Response to Reviewers

Manuscript ID: 26-0767

"Simultaneous Contact Selection and Planning for Contact-Rich Manipulation with Cascaded Optimization"

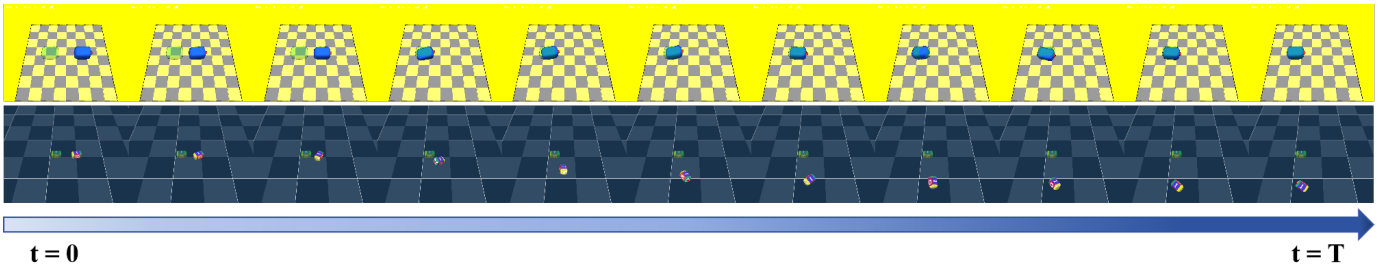
- STOCS / STOCS-3D: this is the closest prior work in spirit, since it directly addresses simultaneous trajectory optimization and contact selection with high-fidelity geometry. Even if it is not real-time, it should be used as an offline planning-quality reference or excluded with a clear justification.

We additionally include STOCS-3D and ContactSDF in the comparison. STOCS-3D is a CITO method that cannot be evaluated online in our setting and does not switch contact

points during execution. Given the initial and target object poses, we compute one contact trajectory offline with STOCS-3D and execute it through OSC. ContactSDF provides a differentiable contact model but does not perform explicit contact selection. The resulting comparison is reported in Table II.
